PLANNING COMMISSION REGULAR DOCKET TUESDAY, July 9, 2019 at 5:30 P.M. CITY COUNCIL CHAMBERS

- 1. <u>Minutes</u> June 11, 2019 Pre- meeting and Regular meeting
- 2. Minutes June 25, 2019 Work Session
- 3. <u>ZTA Initiation</u> Access Management
- 4. Preliminary Site Plan Gallery Court Hotel
- 5. <u>Preliminary Site Plan</u> 901 River Road

SHEET C3 of 7

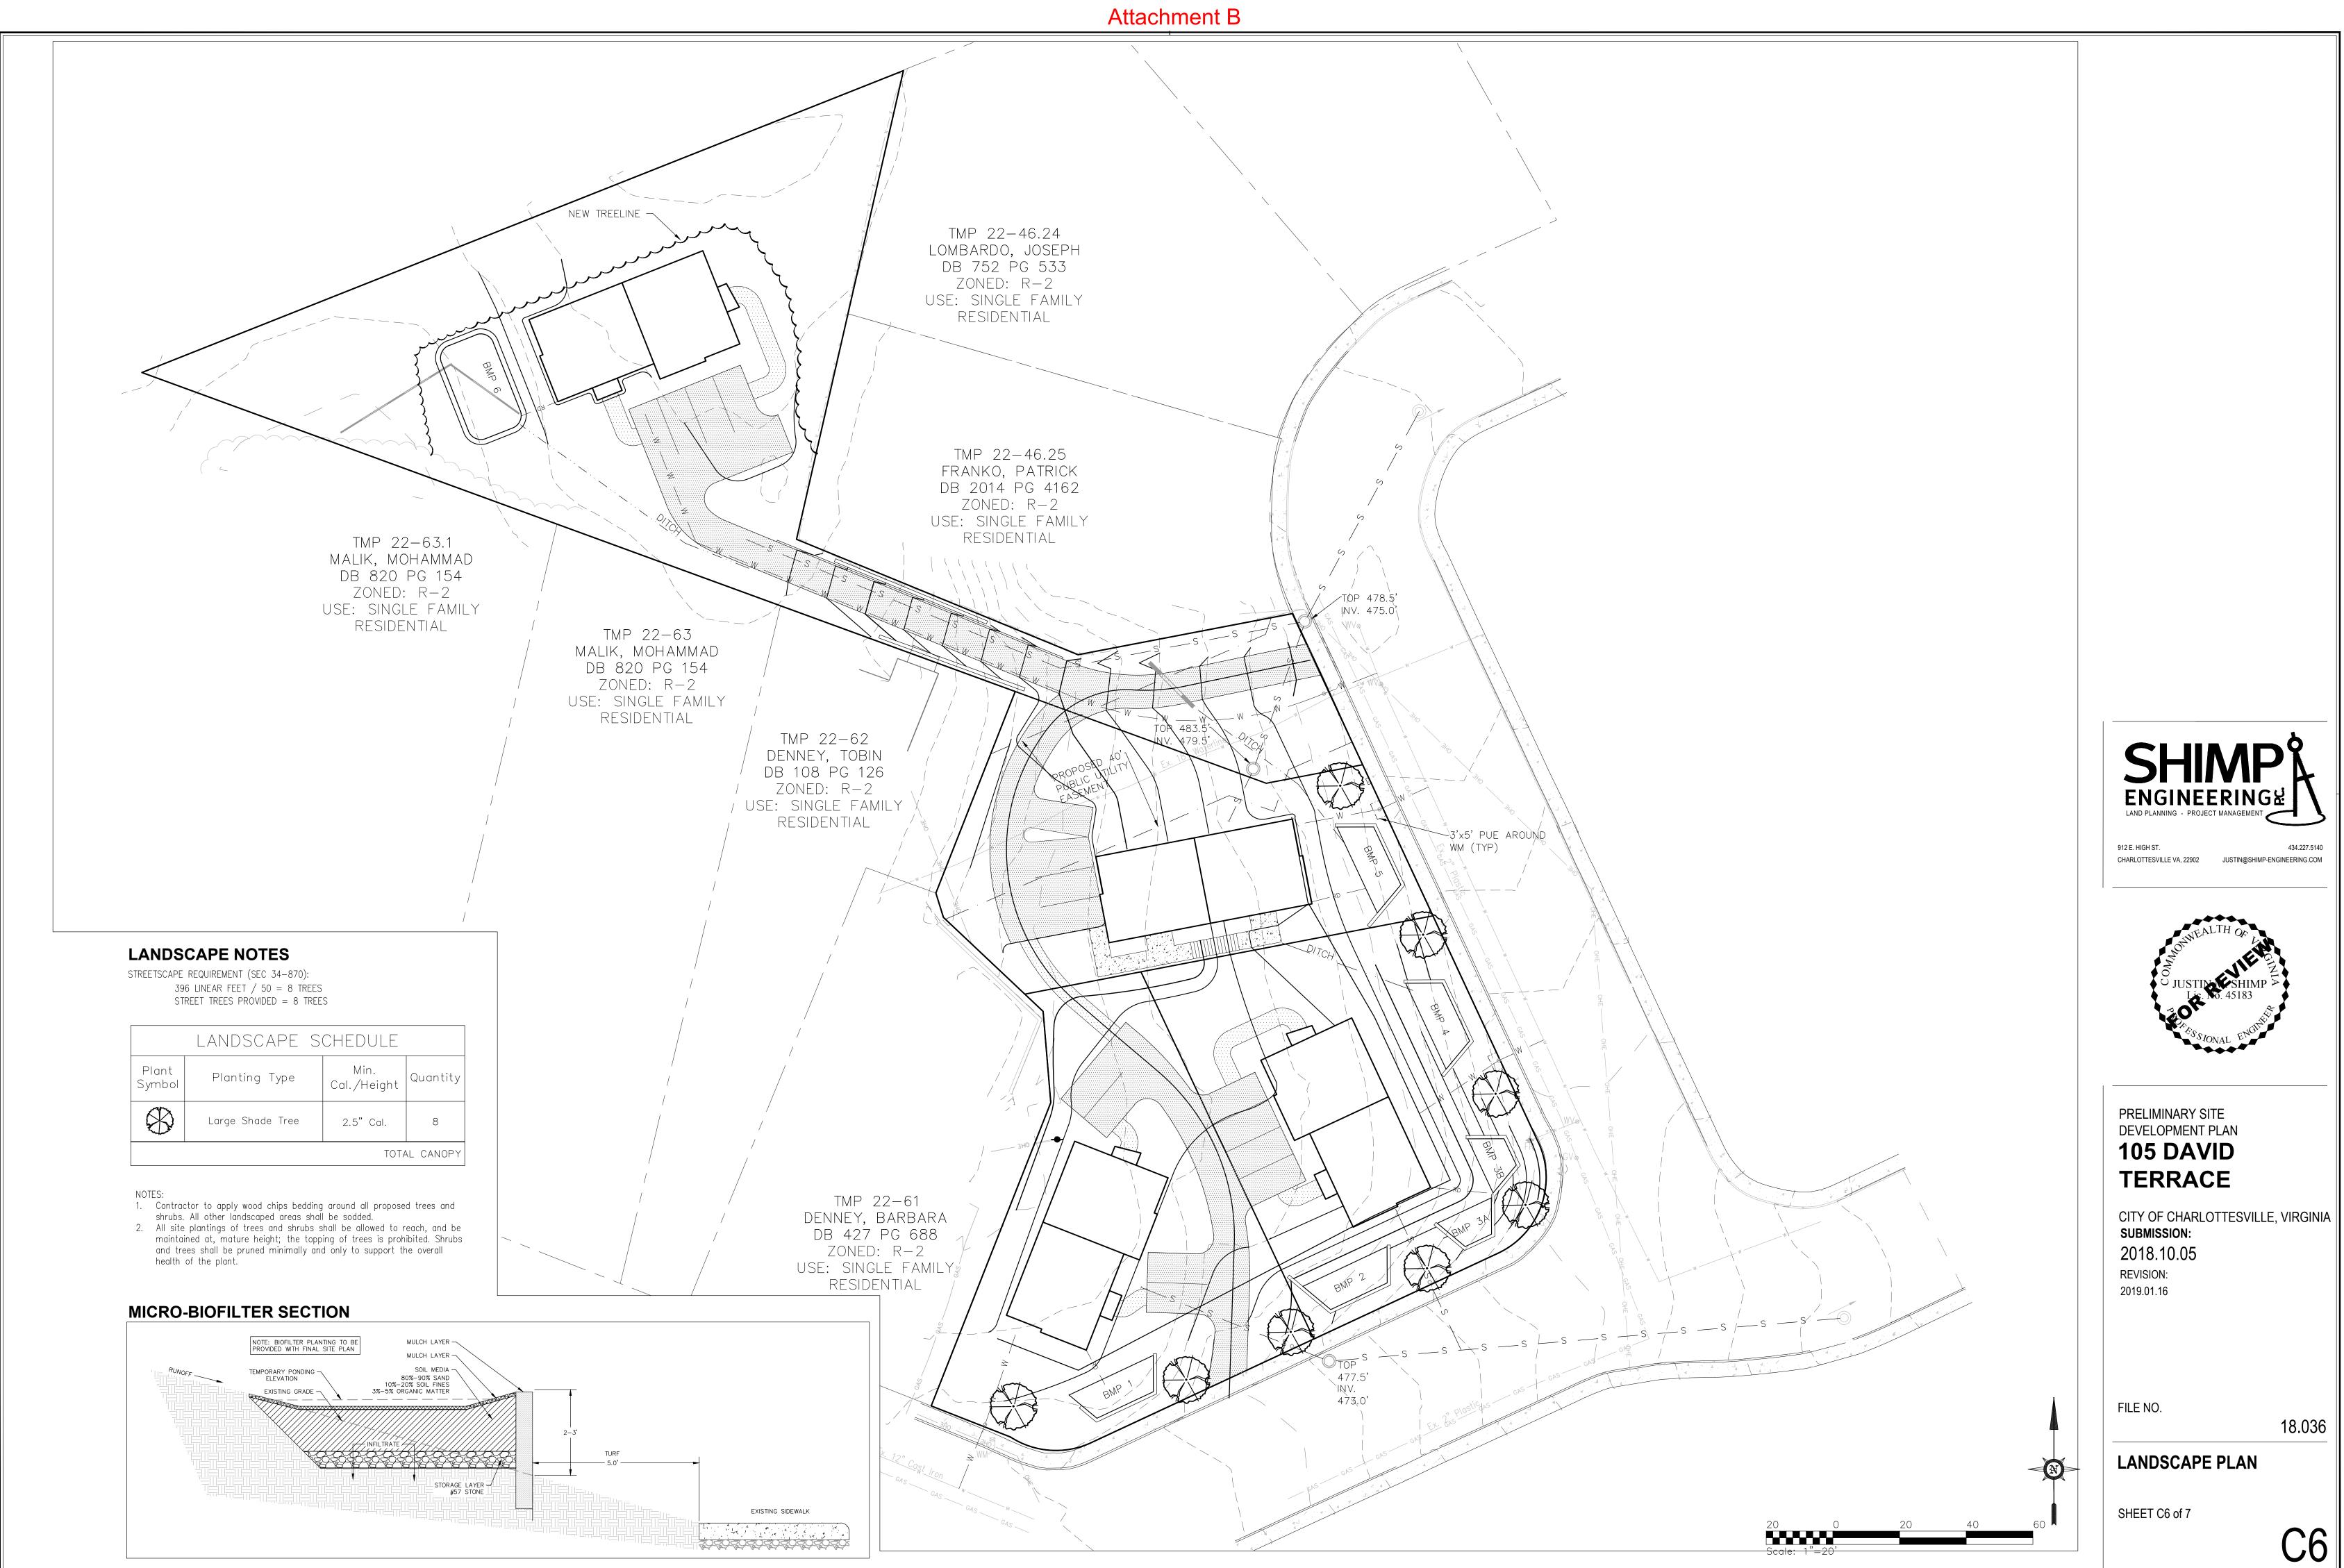
- 16. (F) Please provide a detail for the street tree root barrier. Please specify size, depth, and make / model.
- 17. (F) On sheet C4, if the retaining wall adjacent to the storm run from F3 F2 remains, please note that no part of the wall (footer, geogrid, tieback, etc) can extend into City ROW. Also, please note that the wall shall be designed such that the City can excavate a 6-foot wide trench centered on the storm line to a depth of 6-inches below the pipe invert (or structure invert) and this excavation will not affect wall stability / footer. This may require an extra-deep footer.

- 18. (F) On sheet C4, the new building is shown to be constructed adjacent to existing overhead lines along Belleview. Please confirm this is acceptable to the overhead utility line owners. If not, show any necessary pole relocation / undergrounding as a part of this site plan.

- 21. (P) On sheet C4 storm line F3 F2 shall be 15-inch RCP minimum.
- 22. (F) On sheet C4, please remove the proposed retaining wall from the proposed utility easement for the storm line F3 F2. We do not need a proposed obstruction where a relocated pipe is proposed.

- 23. (F) On sheet C4 for the private storm run between Y1 and C2, we do not recommend installing a bend in the line as shown. As this is a proposed private line, this is only a recommendation.

- 30. (F) On sheet C4, is there any desire for the proposed retail / coffee shop to have its own water meter? If so, please show as such and provide demand calculations.

- 31. (F) On sheet C4 for the 5/8 water meter serving the storage building, please note this meter shall be served by a ¾-corp stop (tap) on the main and ¾-inch type K copper service line. There should not be a TS&V reference for this connection.

- 32. (F) On sheet C4 for the 5/8 water meter serving the storage building, please show the proposed meter box to scale.

- 33. (P) Repeat Comment: On sheet C4, for the new sewer cleanout along River Road, please provide this as close to the ROW/property line as possible while remaining out of the concrete entrance.

- 34. (F) On sheet C4 for proposed manhole S3, please remove the drop MH label. This should be a standard manhole.
- 35. (F) On sheet C10 for the sanitary sewer profile, please remove the proposed drop in manhole S3. Please show this with the normal 0.2-feet of fall across the manhole. Per City standards, drops are only allowed where necessary, and there is nothing shown that would necessitate the drop.
